Index 411 Pier Protection Barrier

COMMENTARY

COMMENTS AND RESPONSES

BLACK = Industry Review Comments **RED** = Standard Plans Response

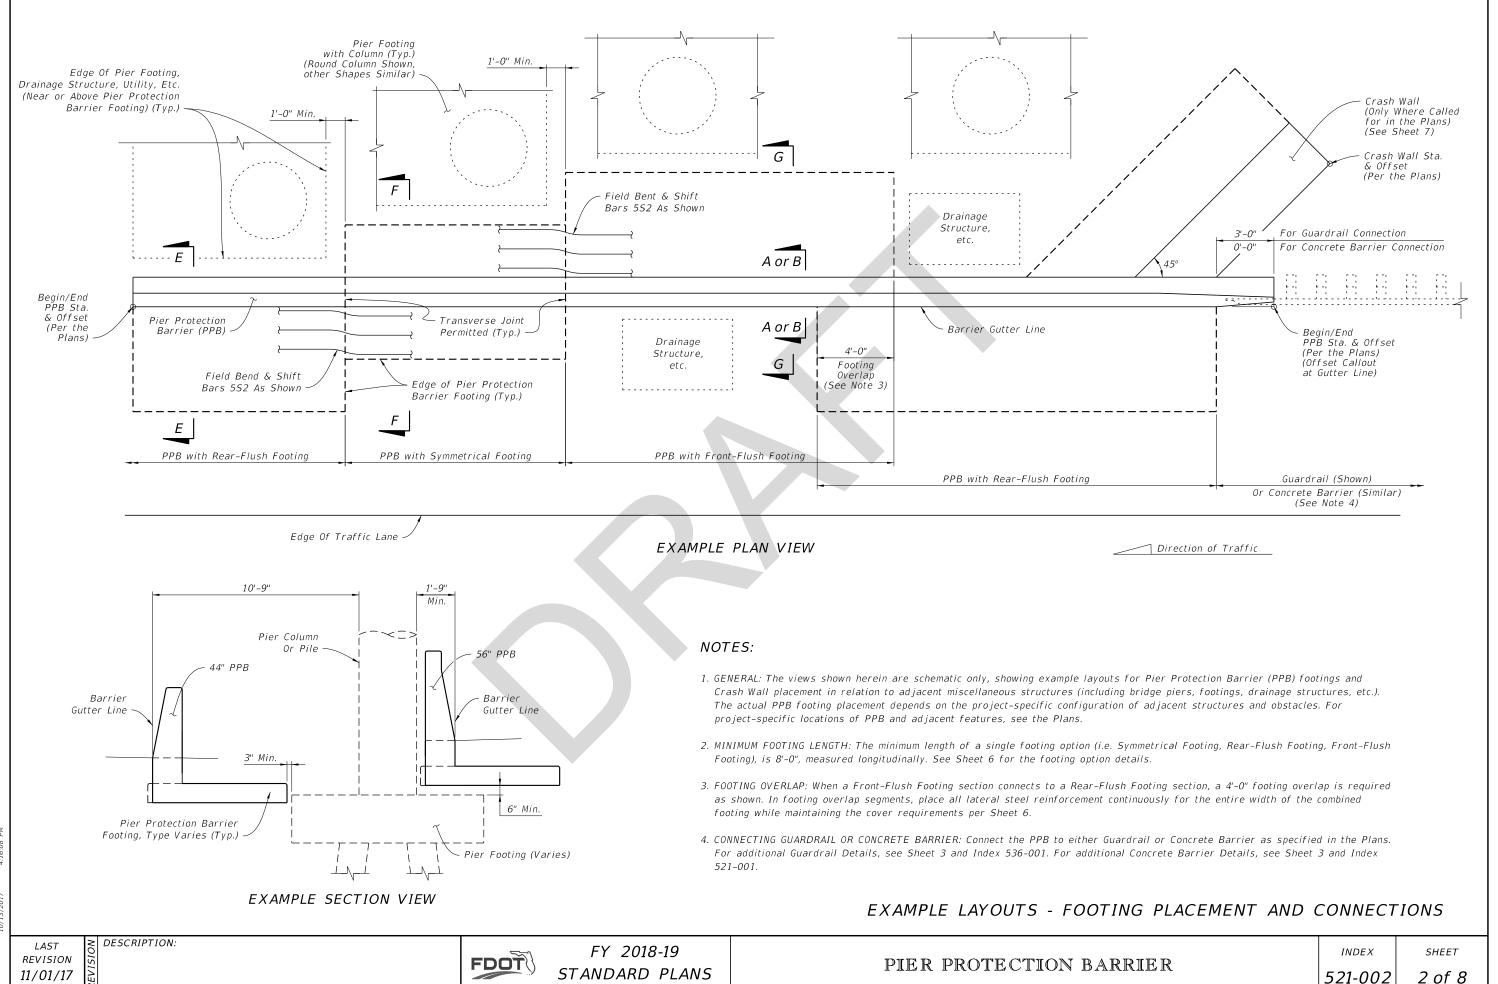
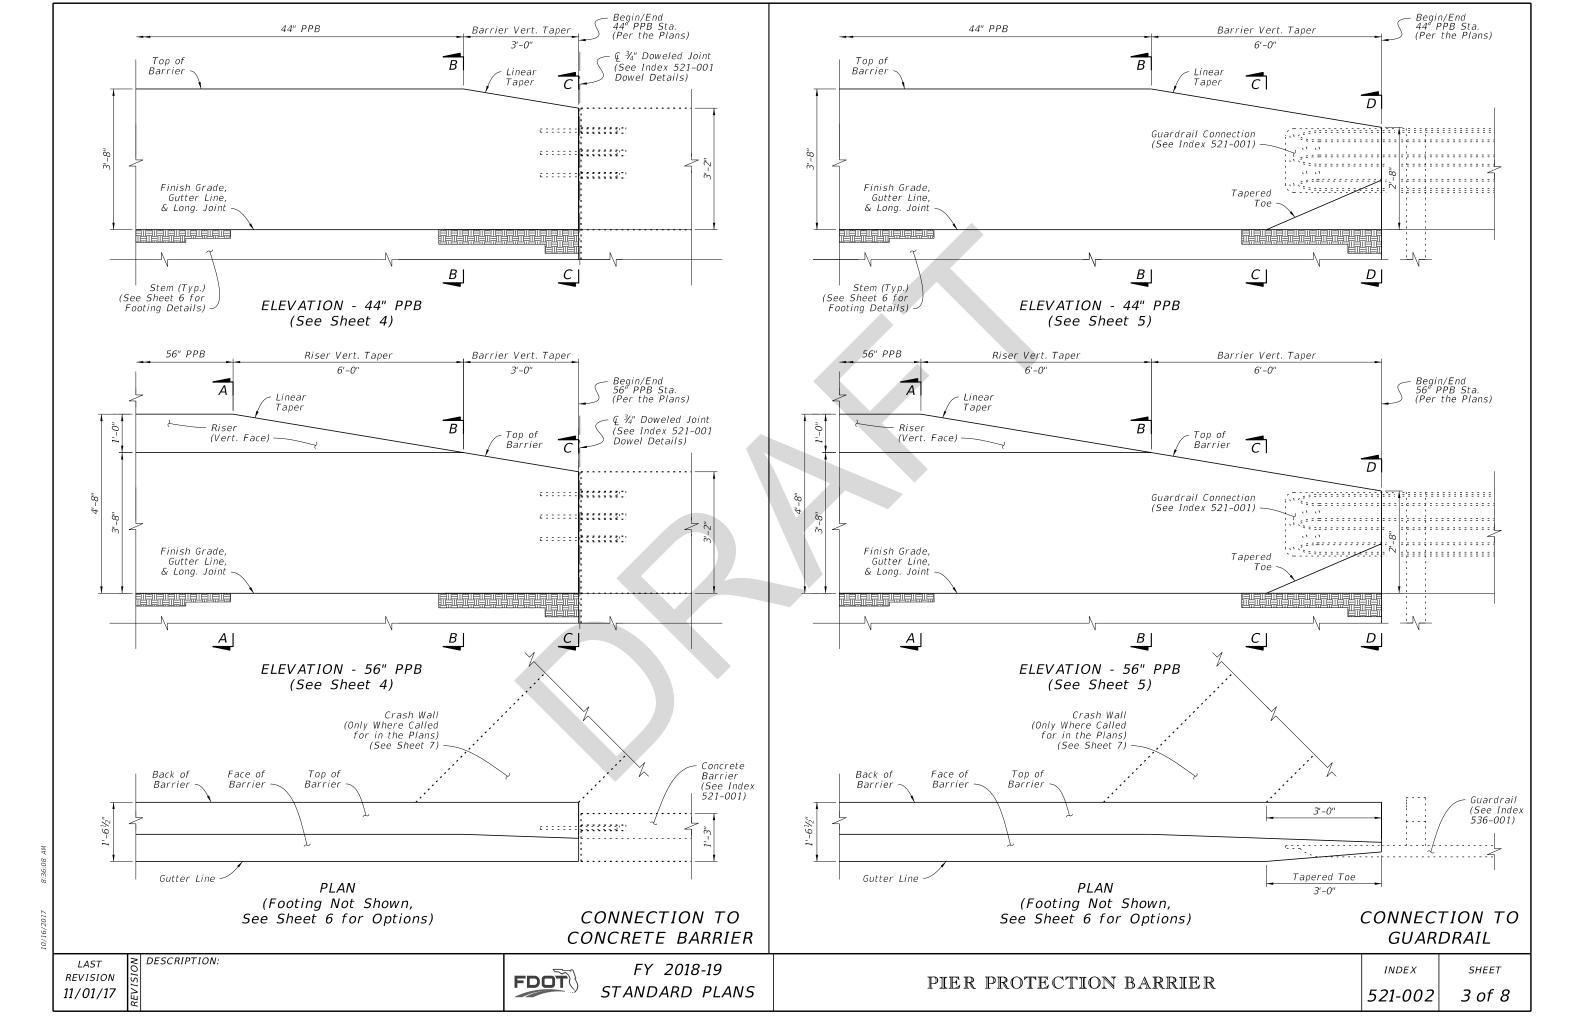
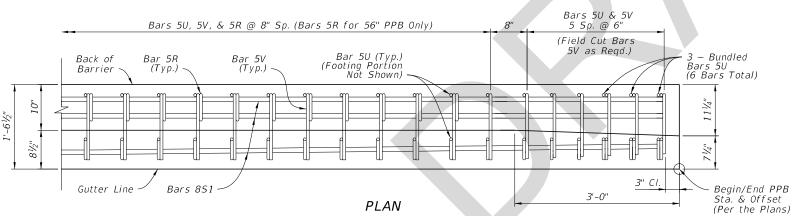
Sheet 1 of 8 (General Notes): Note 3 indicates the compaction (density) requirement for the top 12-in. of sub-grade. For consistency with the Specifications, it appears that the note should read ".....98% of the Modified Proctor maximum density......."

The compaction (density) requirement (98% of the Modified Proctor maximum density per FM 1-T180, Method D) is the same as given in the Specifications for STABILIZING (see Specs. 160-4.2.3.1 and 160-4.3.2.3). For consistency with the standard Roadway pavement stabilizing requirement shown in the Plans, please consider modifying the general note by indicating "Type B Stabilization, LBR 40 (12-in.)", rather than indicating the Specifications requirement. This should be specified at least for the standard median barrier (2-ft. wide at bottom) where the Type B Stabilization would be extended below the barrier from the adjacent roadways.

Agreed. Change made.

Updated to instead reference equivalent "Type B Stabilization"

- 3. SUBGRADE: Compact the top layer of subgrade with Type B Stabilization, LBR 40 (12 in.).
- 4. DRAINAGE INLETS: See Index 425-001 for Shoulder Barrier Inlets, and isolate these structures from Pier Protection Barriers and Footings with 1" Preformed Joint Filler.

BARRIER DETAILS - CONNECTION TO CONCRETE BARRIER

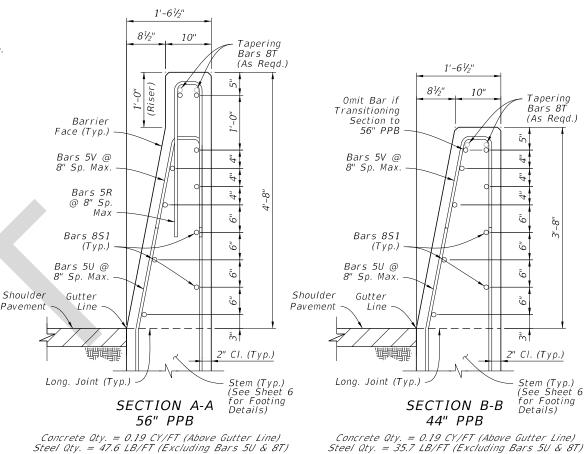
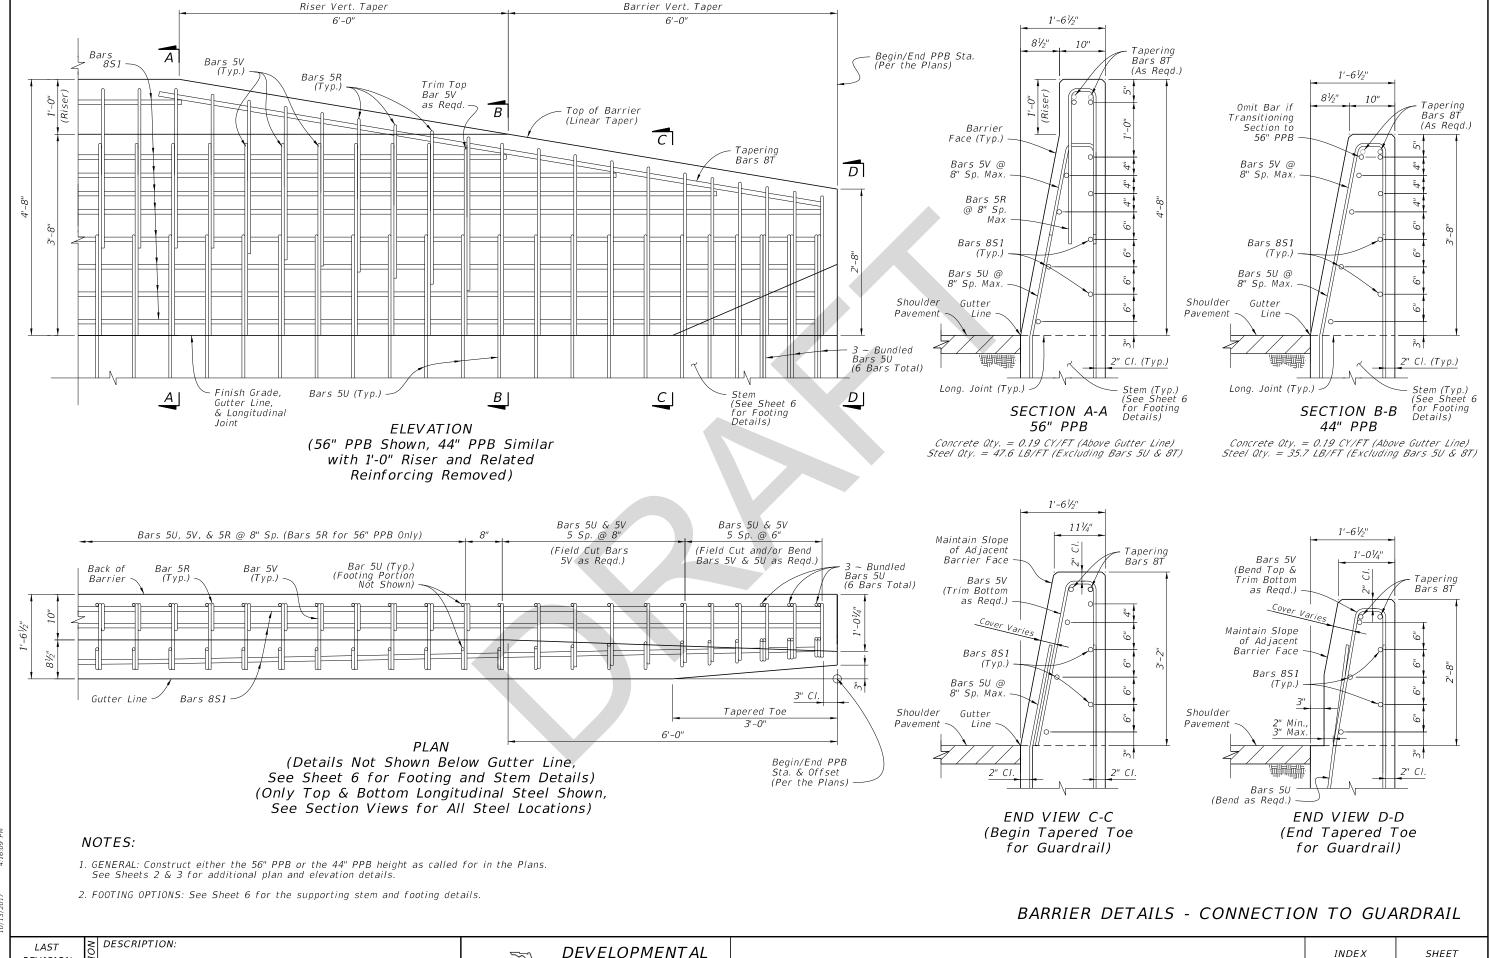
<u>Longitudinal V-Grove</u> – We are asking that the $\frac{1}{2}$ " V-Grove be removed from the standard. This is going to cause a lot of headache for both slip-form and hand form barrier.

- a. In slip-form, any jump, or knock, or movement in the machine what-so-ever will show up in the face of the wall. By adding this V-Grove, this will be magnified. It will be an "eye sore".

- b. The Concrete Finishers will have a very difficult task of trying to finish around the V-Grove. As you know, behind the slip-form machine, finishers have to quickly wipe the walls using trowels, darbies, and brooms. Trying to keep from filling in this ½" grove while working 1"-2" above finished grade is going to add in labor costs.

- c. Any type of material that runs down the wall is subject to fill in the grove.
- d. When forming by hand, it will be almost impossible to match up the V-Grove between sections.

- e. Asphalt folks are going to have a time with this, too. If the asphalt roller drum gets too close to the V-Grove, they run the risk of the barrier cracking along this longitudinal grove. The ½" grove creates a weak plane. If the roller does not roll the asphalt down even at the edge against the wall (as they are subject to do), the asphalt can cover / fill in the V-Grove.

- f. General Note #9 gives a tolerance of ½" to the finish grade pavement. This will result in the pavement fluctuating up and down, which <u>WILL NOT</u> be visually smooth and even. The V-Grove will be creating a line that shows every little fluctuation in finished grade. At this point, what will you do? What will be done?

- g. How will the V-Grove be handled when transitioning to a bridge? Will the transition have the grove, or will it play out along the transition, or just abruptly stop at the beginning of the transition?

Agreed. Longitudinal V-Grooves will be removed to lessen potential for construction complications and delays. Change made.

Removed longitudinal V-grooves throughout (all Index Sheets)
